## SMART Board® 885ix interactive whiteboard system power supply addendum (projector Part No. 03-00157-20 or -21)

This document applies only to SMART UX60 projectors that are marked with Part No. 03-00157-20 or 03-00157-21 and that are used with a SMART Board® 885 interactive whiteboard. It does not apply to SMART UX60 projectors used with SMART Board 685 interactive whiteboards.

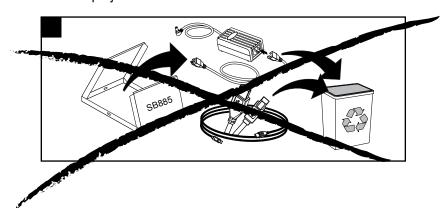
- 1
- Do not recycle the power cable as illustrated in the installation guide you received with your system. Instead, use the power cable to power your interactive whiteboard system.
- Powering your interactive whiteboard from the SMART UX60 projector as described in the installation guide can cause erratic projector behavior.

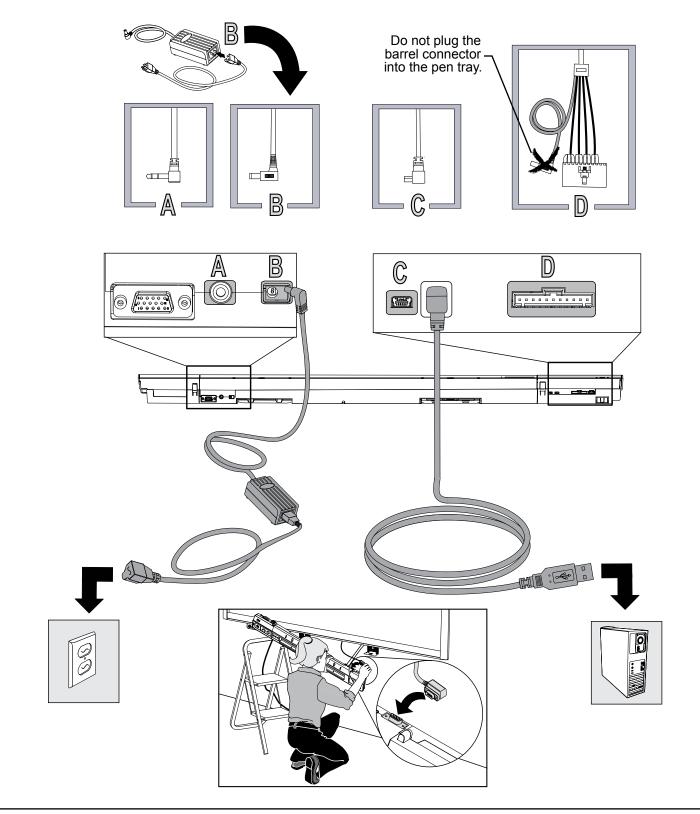
Do not connect the pen tray of your SMART Board interactive whiteboard as illustrated in the installation guide you received with your system. Instead, refer to the following instructions.
